Extraordinary Local Traffic Committee Meeting

Report No. 5.1 New Intersection on Bangalow Road

Report No. 5.2 Traffic Management Plan – Splendour in the Grass Campground at Bluesfest, 35 Yarun Road, Tyagarah

SITG 2022 – BEF camping and shuttle Traffic Management Plan

<u>REGULATORY MATTERS</u> <u>5.1 - ATTACHMENT 1</u>

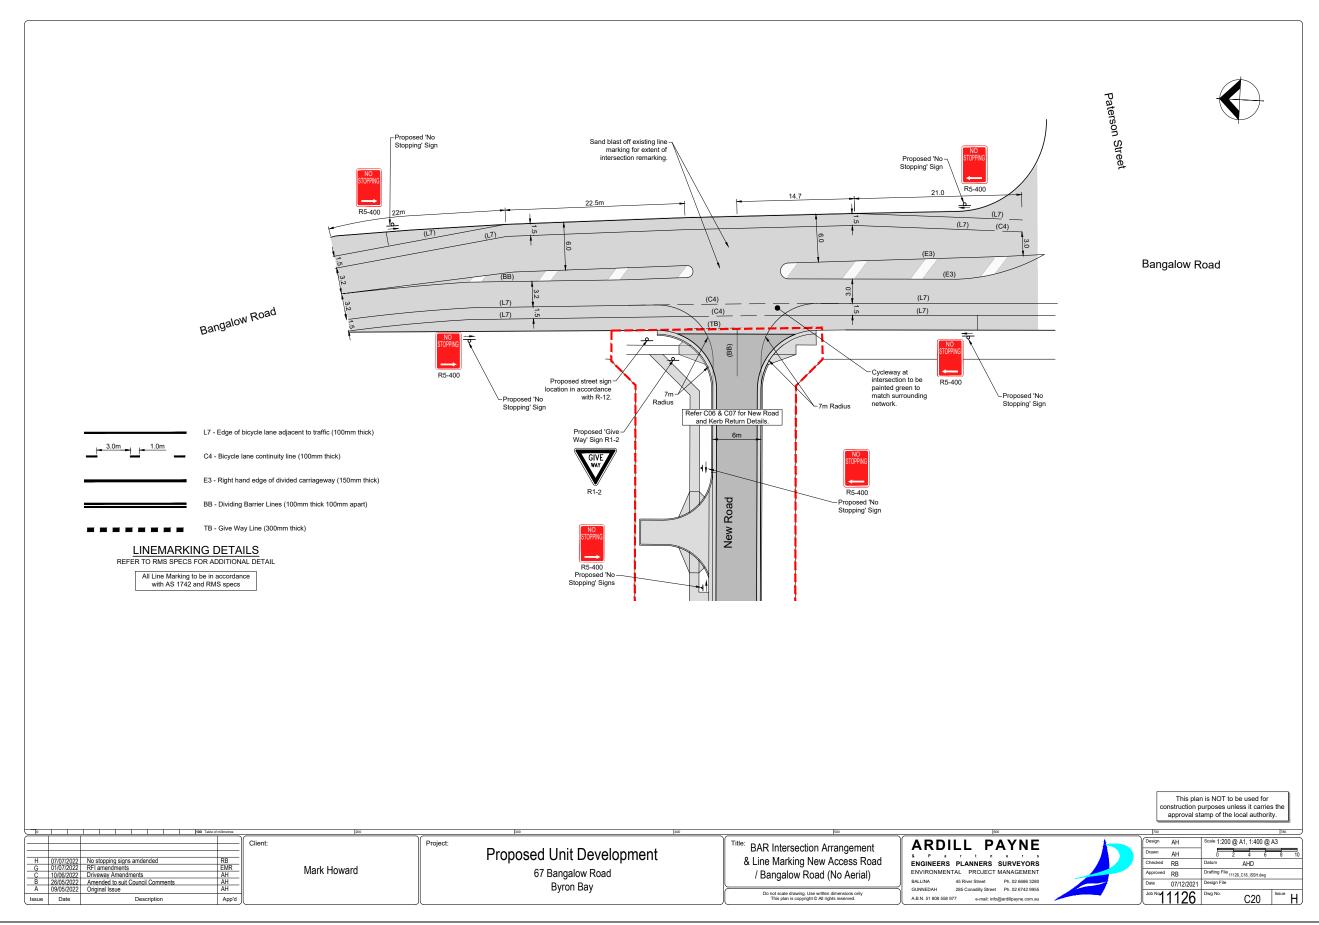
- 10 1. Return report to show correct signage ("no stopping" R5400);
 - 2. Consider left turn only and stop sign from new road onto Bangalow Road; and
 - 3. Advise on the purpose of the no stopping signage and the consultation that had occurred.
- The purpose of this LTC report is to gain support for the proposed <u>regulatory signage and</u>
 15 <u>line markings</u> shown in attachment 1.

- 1. No stopping signs R5400 have been revised and updated on the drawing shown in attachment 1.(E2022/63543)
- 2. Intersection design and review was undertaken as part of the development application assessment with comment from TfNSW, and conditioned accordingly, refer below. Further review was carried out on the detailed design submitted with the S138 Road Act application in consultation with TfNSW and TfNSW concurrence was granted 6.7.22, refer Attachment 2 (E2022/62991).
- 3. Consultation occurred as part of TfNSW concurrence in regard to on-street parking within the functional area of the intersection to be identified on detailed plans, as provided in attachment 1, no stopping signs have been provided to achieve safe site distances when cars are leaving the site.
